PIC32MM0256GPM064 FAMILY

PIC32MM0256GPM064 Family Silicon Errata and Data Sheet Clarification

The PIC32MM0256GPM064 family devices that you have received conform functionally to the current Device Data Sheet (DS60001387**D**), except for the anomalies described in this document.

The following typographic corrections and clarifications are to be noted for the latest version of the device data sheet (DS60001387**D**):

2. Module: Pin Diagrams: 48-Pin UQFN, TQFP

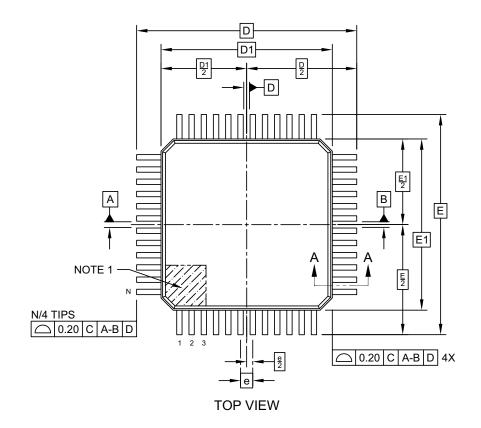
Note 3 is applicable for the 48-pin UQFN package only. The Thermal pad is not available on the 48-pin TQFP Package.

48-Lead Plastic Thin Quad Flatpack (Y8X) - 7x7x1.0 mm Body [TQFP]

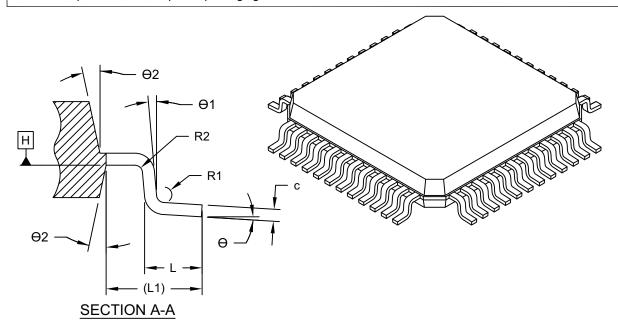
The following figure shows the updated package drawing for the 48-Pin TQFP Device:

4. Module: Pin Diagrams: 64-Pin QFN, TQFP

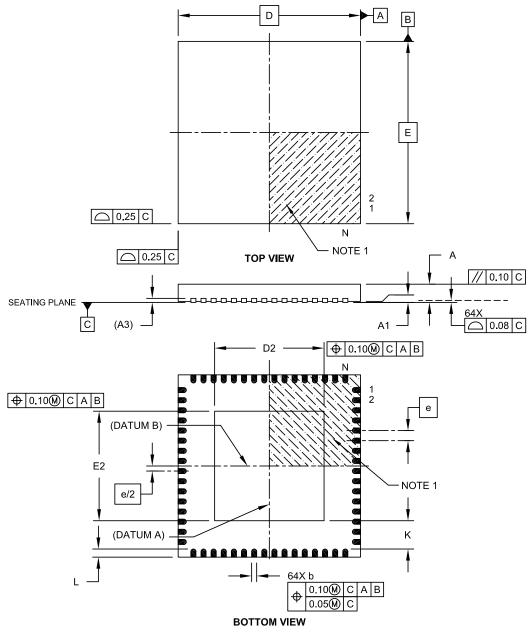
Note 3 is applicable for the 64-pin QFN package only. The Thermal pad is not available on the 64-Pin TQFP package.

64-Lead Plastic Quad Flat, No Lead Package (MR) – 9x9x0.9 mm Body with 5.40 x 5.40 Exposed Pad [QFN]

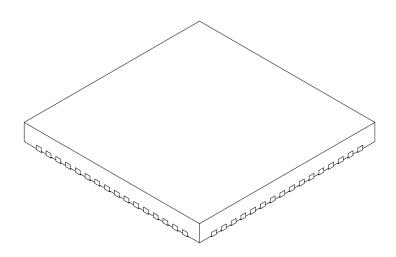
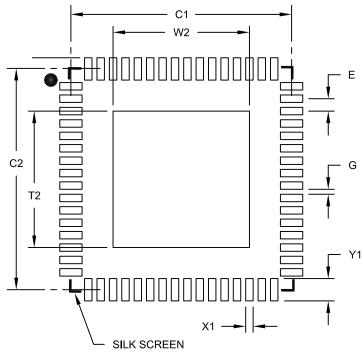
The following figure shows the updated package drawing for the 64-Pin QFN device.
